DOCTYPE: LETTER NOTARIZED: NO COPIES RECEIVED  
SUBJECT: LTR 1 ENCL 1  
RESPONSE TO NRC LTR DTD 05/23/78... FORWARDING ADDL INFO REQUIRED TO CONTINUE  
NRC REVIEW OF "REPT ON LARVA FISH ENTRAINMENT FOR THE YEARS 1975-1976", FOR  
SUBJECT FACILITY.

PLANT NAME: BELLEFONTE -- UNIT 1  
BELLEFONTE - UNIT 2

REQUEST FOR ADDITIONAL INFORMATION ON THE  
"REPORT ON LARVAL FISH ENTRAINMENT FOR THE YEARS 1975-1976"  
FOR THE BELLEFONTE NUCLEAR PLANT

Figure 2. Number of fish larvae (all species combined) per m<sup>3</sup> for each subarea of the cross sectional profile at TRM 392.2. Data are for sample period 14 at the Bellefonte Nuclear Plant site in 1976.

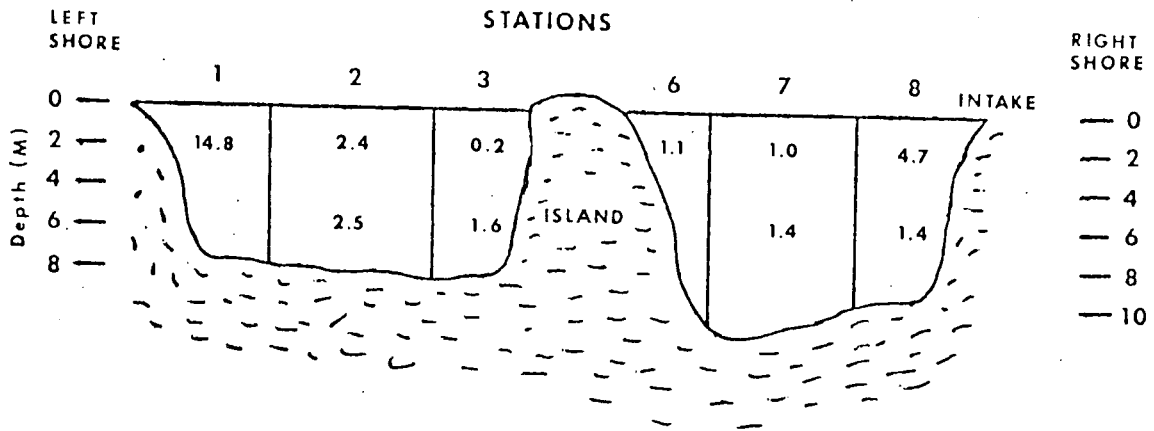
3. Provide the densities (total number of larvae per  $m^3$ ) for each subarea of the cross-sectional profile for one sample date (e.g., sample period 14 in 1976). This might be presented in the manner of Figure 2 of the referenced report by Marcy. For this example case, demonstrate the analytical method in arriving at the estimated entrainment of total fish larvae (N and %) as presented for the sample period (No. 14) in Table 5.

$N_t$  determined using the data in Figures 1 and 2 was  $3.909 \times 10^8 \text{day}^{-1}$ .

Because strata volumes at stations where more than one depth was sampled were similar; the densities (as given in Figure 2) were averaged for computational simplicity.

The number of larvae (all species combined) per  $m^3$  for each subarea of the cross-sectional profile during sample period 14 at the Bellefonte Nuclear Plant site in 1976 is presented in Figure 2.

Figure 1. Station weights for the Bellefonte Plant transect at TRM 392.2 in 1976, and for the station and strata vulnerable to the intake of the plant.

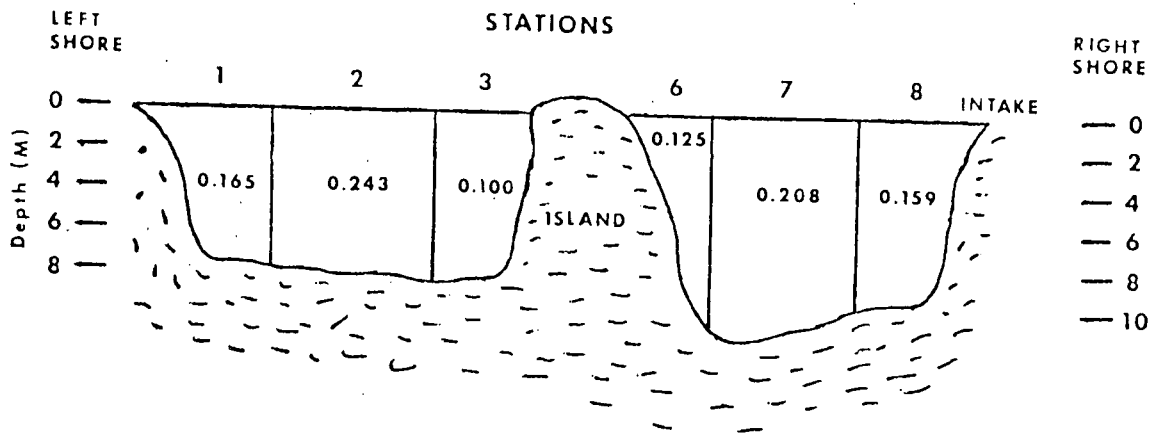
2. Provide the values for the station weights ( $W_s$ ) used in the analytical procedures. It is unclear whether gear efficiencies are included within the weight.

The requested station weights are shown in Figure 1. The values approximate the cross-section component of each station at TRM 392.2. Values for both the entire river width and for the presumed zone of intake influence are shown. They sum to 1.0 in both instances.

All data used for quantitative ichthyoplankton estimates at the Bellefonte Nuclear Plant site in 1976 were collected with the same gear type, a towed net 0.5 m square. Gear efficiencies are therefore presumed to be 100 percent (or at least similar) for all areas and consequently are not included in the weighting factors.

• Figure 3. Estimated number of larvae entrained by sample date.

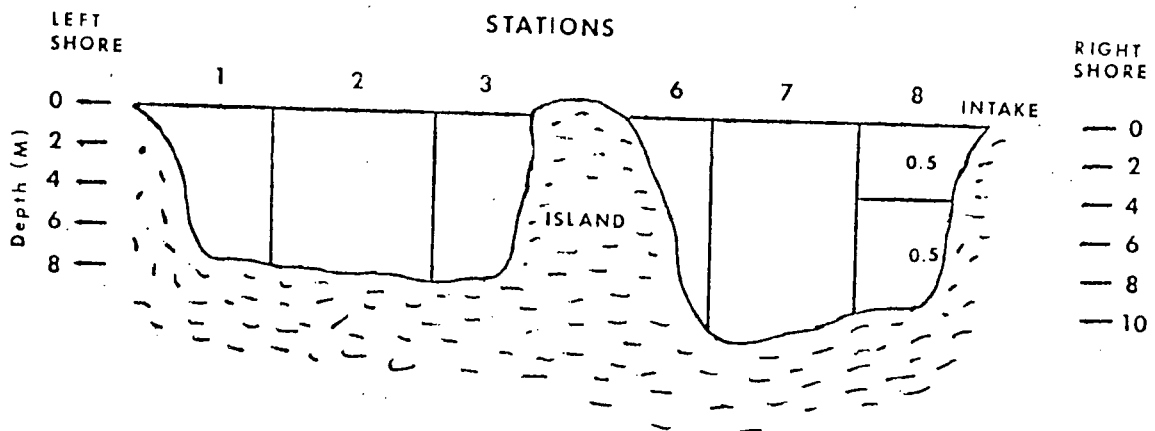
4. What integration technique is used to obtain estimates of the annual entrainment and river transport?

Numbers of ichthyoplankters entrained during a 24-hour period were calculated using the method given in the preceding response for each sample date. These were then plotted (computer modeled) as in Figure 3, and a trapezoidal integration technique employed to determine the area under the curve. This area is an estimate of the total numbers entrained annually.

Computation of the numbers transported past the plant annually was accomplished similarly. Numbers passing the plant during a 24-hour period for each sample date were calculated by the method given in response to question number three. The trapezoidal integration technique was again employed.
